EPC STORMWATER REVIEW COMMENTS
IN ORANGE BOXES WITH BLACK TEXT

Hydraulic Report

Eagleview Regional Drainage Improvements El Paso County, Colorado

Prepared: March 3, 2023

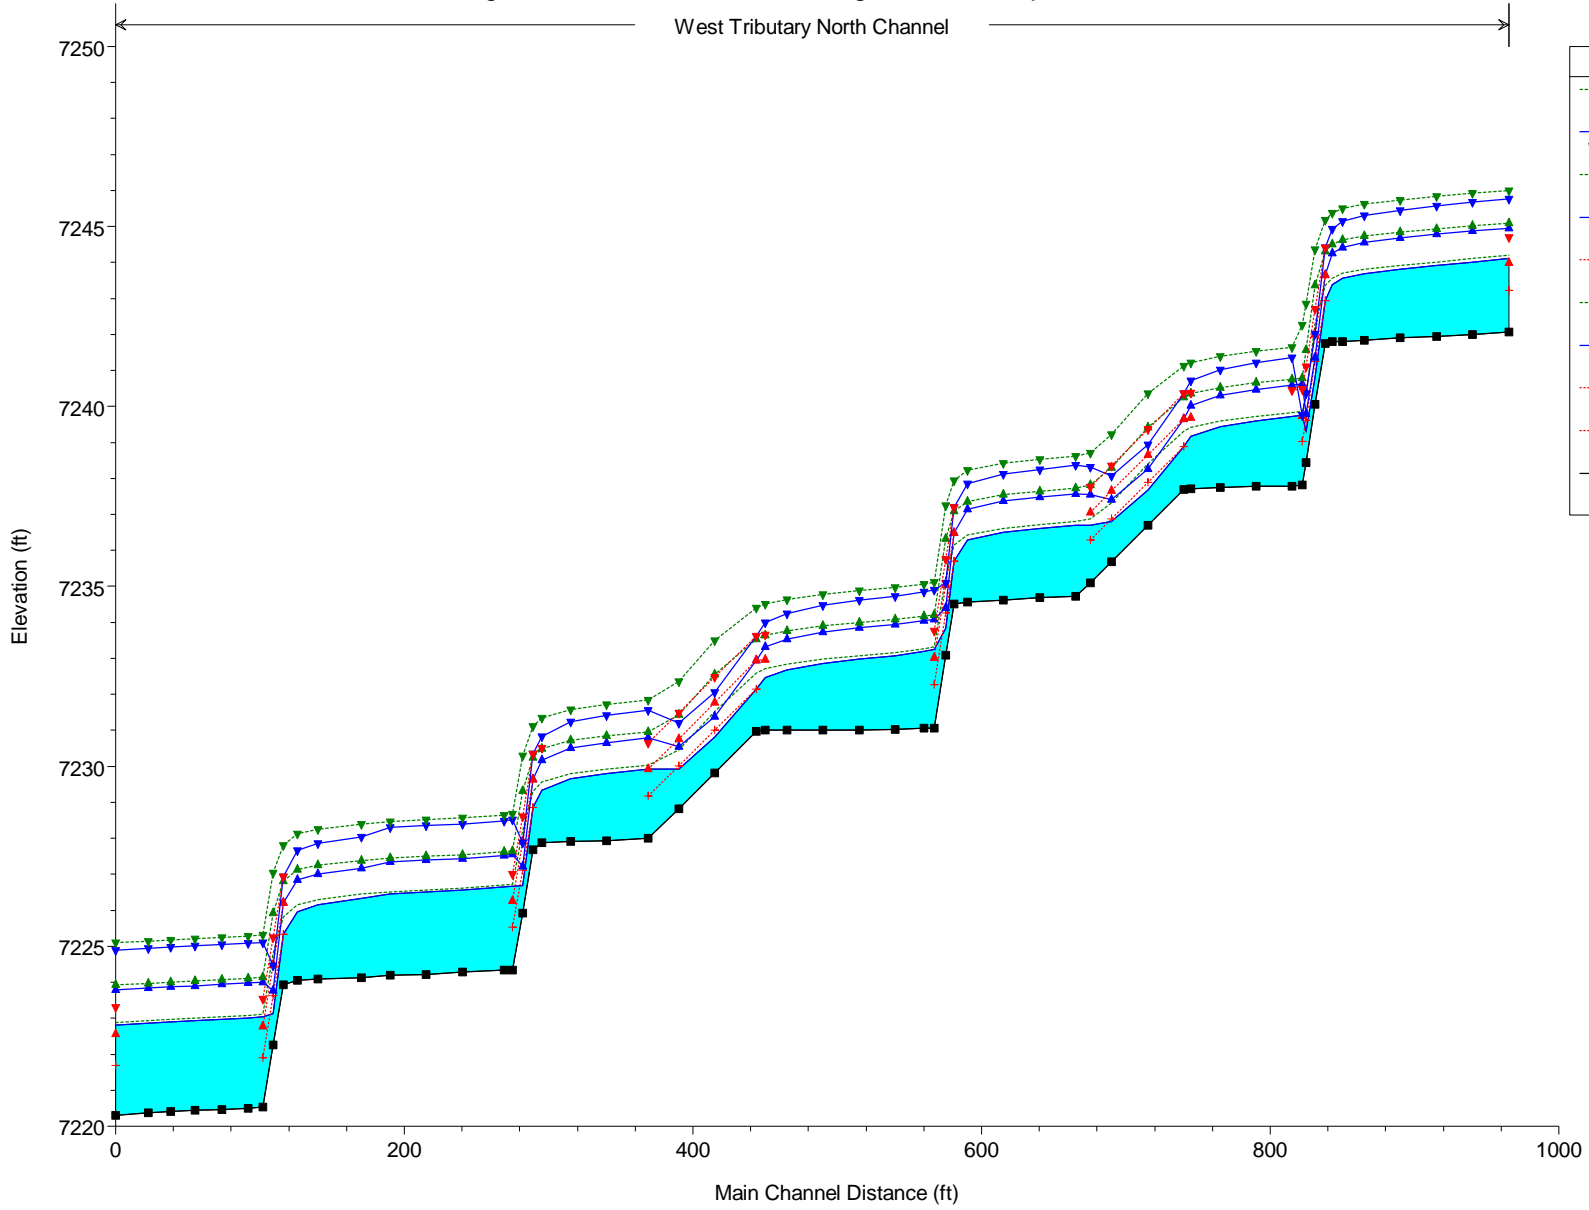
Provide a map showing the corresponding HEC-RAS cross sections for review.

Example below.
